Subject: **ADDENDUM NO.2** VILLAGE POND PARK  
IMPROVEMENT PROJECT (PW 2015.26)

The changes made under this Addendum of the Contract Documents, Specifications, Special Provisions, and Plans for the City of Lake Forest, Village Pond Park Improvement Project (PW 2015.26) are as follows:

1. Revised Plans & Specification Pages - This addenda shall replace the following plan and specification pages with the attached plans & specification pages dated 11/10/16 and marked (**REVISED PER ADDENDA No. 2**).
  - a. Improvement Plan Pages L-3, L-4, L-9, L-17, L-18 and L-19
  - b. Specification Section 00400 Bid Form
  - c. Specification Section 07500 Special Provisions
    - i. Subsection 9 - Measurement and Payment Procedures
2. Added Specification Pages - This addenda add the following specification pages dated 11/10/16 and marked (**REVISED PER ADDENDA No. 2**) to the contract specifications.
  - a. Specification Section 00800 Technical Specifications
    - i. Section 329600 - Transplanting
3. The attached response to contractor Requests for Information and associated exhibits, with regard to the project shall be incorporated into the project contract documents.

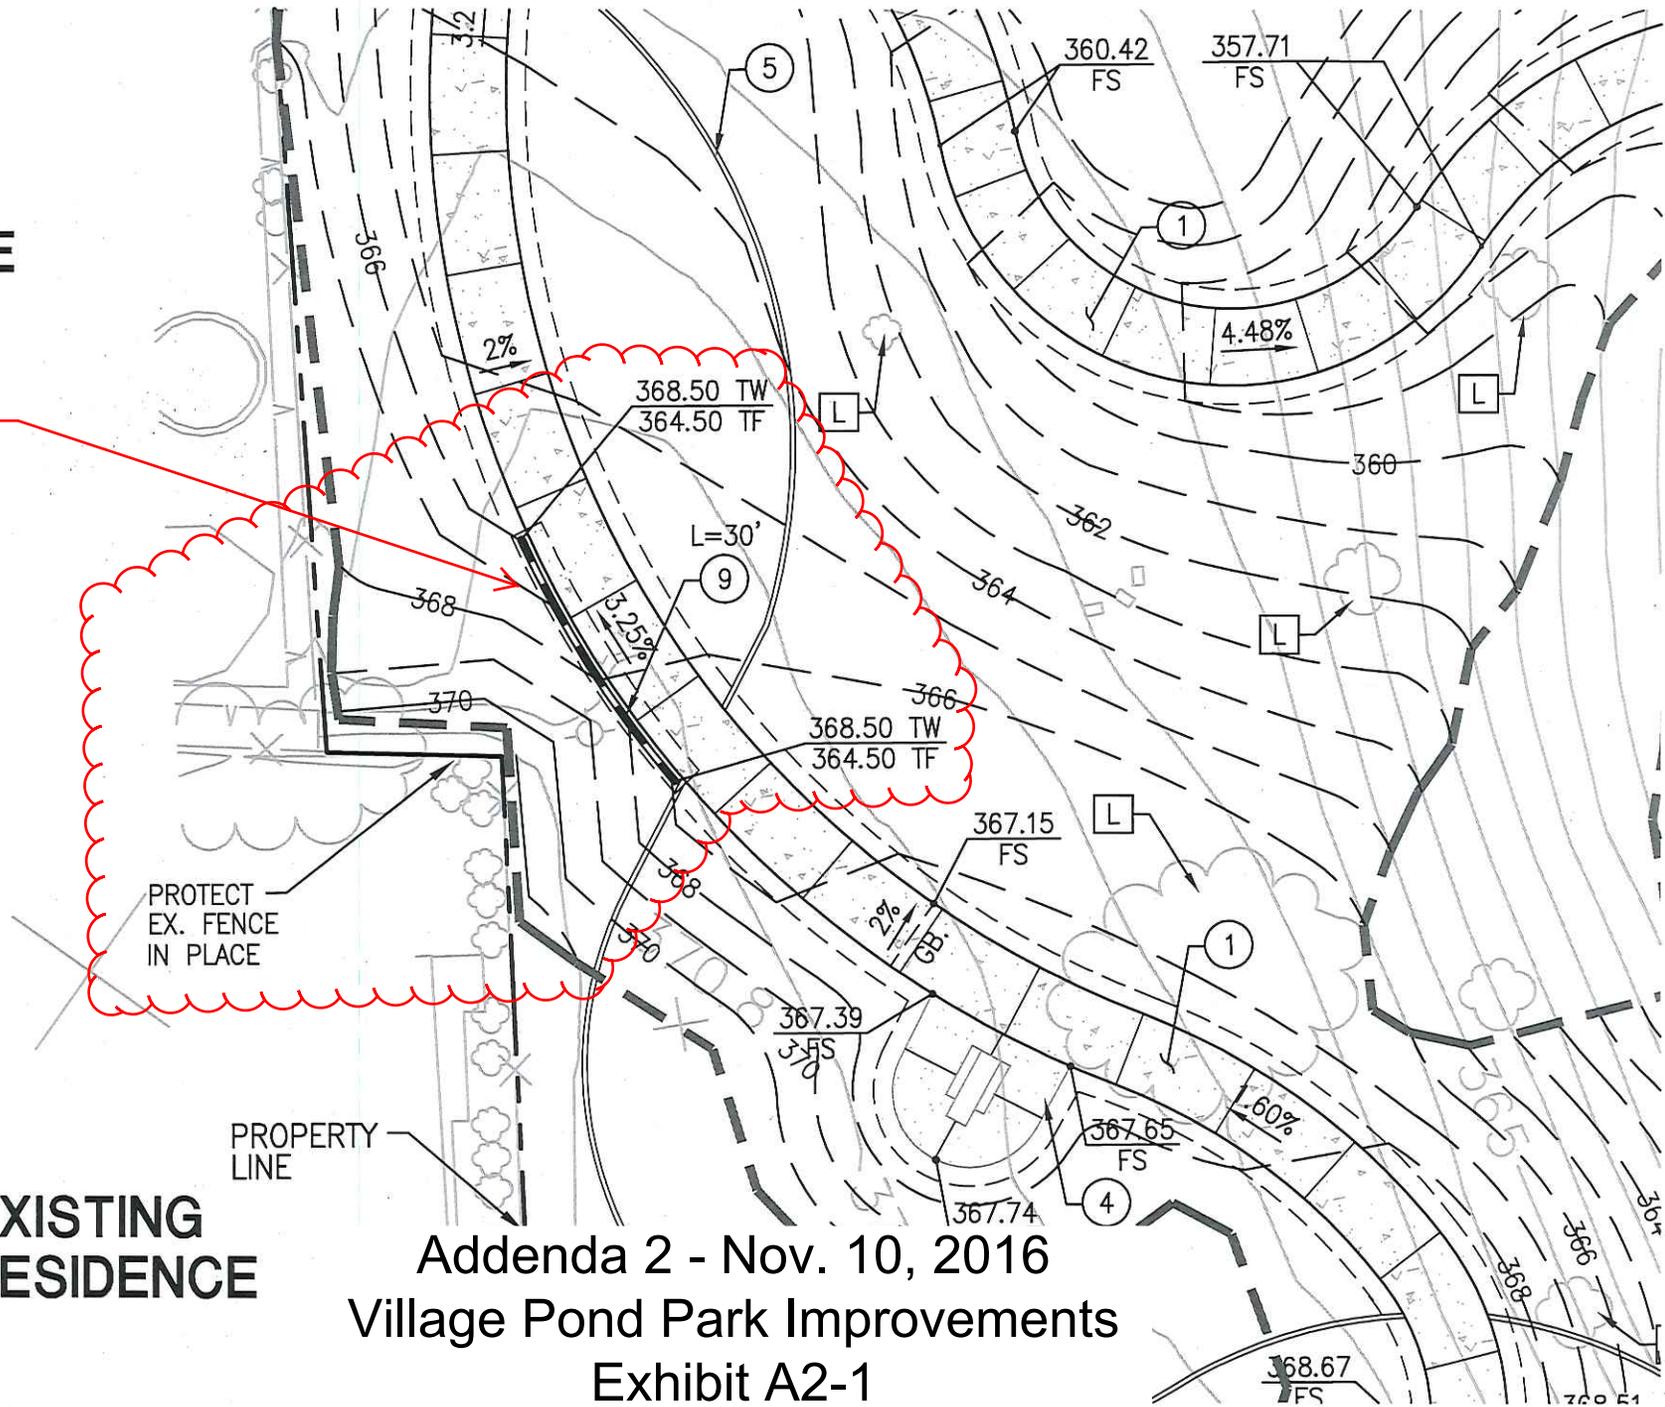
Q25. The soils report recommendations call for various over-excavation and re-compaction requirements for subgrade prep, structural fill, foundations, Etc. Can the City define what requirements the Bidders should include in their bids for these items? Specifically the City needs to define what are the grading requirements under hardscape, pilaster and wall footings, bridge foundations, as well as the general landscape areas. Do we need to figure over-excavating the entire site " X" inches below the subgrade and compacting to 90% before bringing the site up to finish subgrade per the grading plan and compacting the top layers to 90%. Or Is the City's direction limited to grading the finish subgrade per the plan with the only over-excavation and re-compaction requirements under new footings and hardscape areas?

**A25-FOR STRUCTURES WITH SHALLOW FOOTINGS, OVER-EXCAVATE TO A DEPTH OF 3 FEET BELOW BOTTOM OF FOOTINGS OR DEPTH OF UNDOCUMENTED FILL, WHICHEVER IS DEEPER. OVER-EXCAVATION SHOULD EXTEND AT LEAST FIVE (5) FEET Laterally BEYOND THE LIMITS OF PERIMETER FOOTINGS WHERE FEASIBLE. OVER-EXCAVATION FOR RETAINING WALLS, IF ANY, SHOULD BE TWO (2) FEET BELOW BOTTOM OF FOOTINGS AND SHOULD EXTEND THREE (3) FEET Laterally BEYOND THE RETAINING WALL AREA. THE UPPER 24 INCHES OF SITE SOILS SHOULD BE REMOVED IN AREAS OF SIDEWALKS AND HARDSCAPE. THE OVEREXCAVATION SHOULD EXTEND TWO (2) FEET Laterally BEYOND THE SIDEWALK AND HARDSCAPE AREAS. THE REMEDIAL GRADING AND OVEREXCAVATION AND RECOMPACTION RECOMMENDATIONS NEED NOT BE APPLIED TO THE ENTIRE SITE BUT ONLY AS STATED FOR THE SPECIFIED AREAS.**
